## Thor Motor Coach Recall Repair Instructions

Recall #	<b>24V-427 2024-417</b>		
Description/Title:	<b>Power sofa breaker</b>		
Affected Product Line(s):	<b>Certain 2025 Tranquility, Sanctuary</b>		
Service Campaign # :	<b>RC000305</b>		
Repair Code:	<b>Inspect Only: TMCRC10114V  Inspect with Repair: TMCRC10115V</b>	Released Date:	<b>7/22/2024</b>
Time Allowed:	<b>Inspect Only: 0.1  Inspect with Repair: 0.3</b>	Document Revision:	<b>A</b>

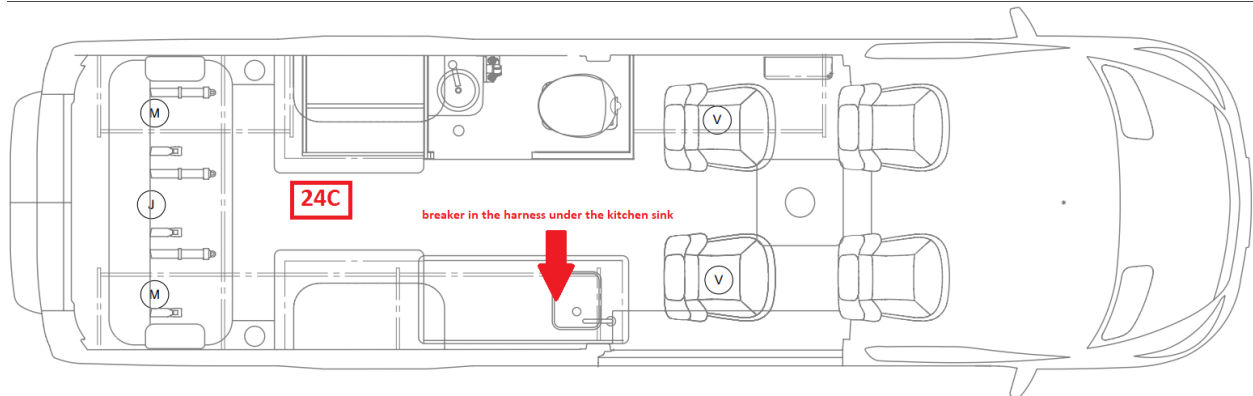
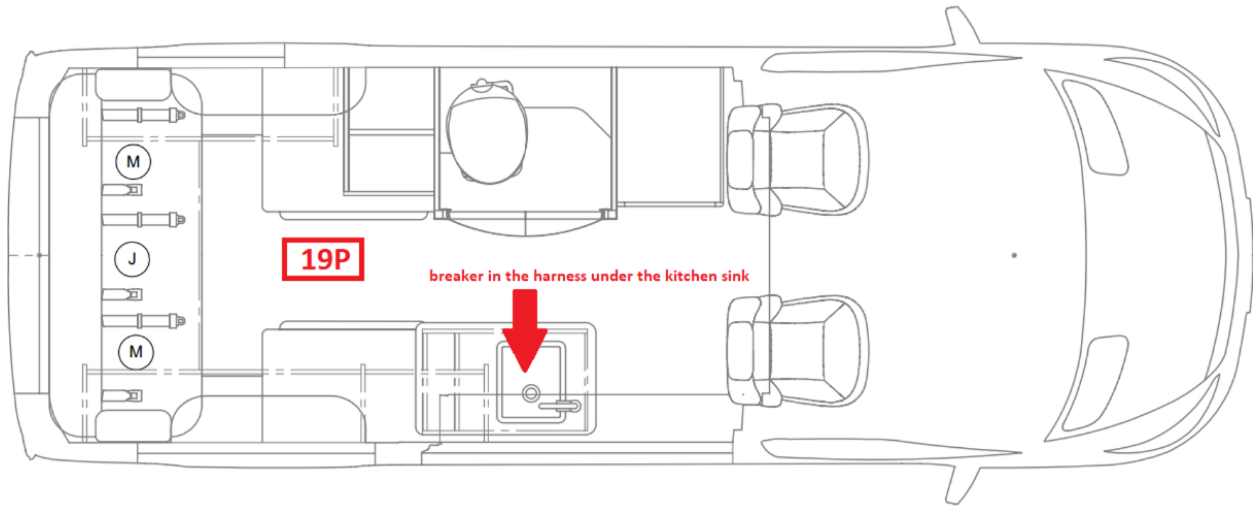
1. The breaker is located underneath the kitchen sink.

2. If the breaker is 50amp, it will need to be replaced with a 20amp breaker. Continue to Step 3.

3. Unplug the coach and turn off the inverter.
4. Disconnect the ground cable from the house battery.
5. Remove the 50amp breaker and replace with 20amp breaker.
6. Reconnect the ground cable to the house battery.
7. Plug the coach back in.
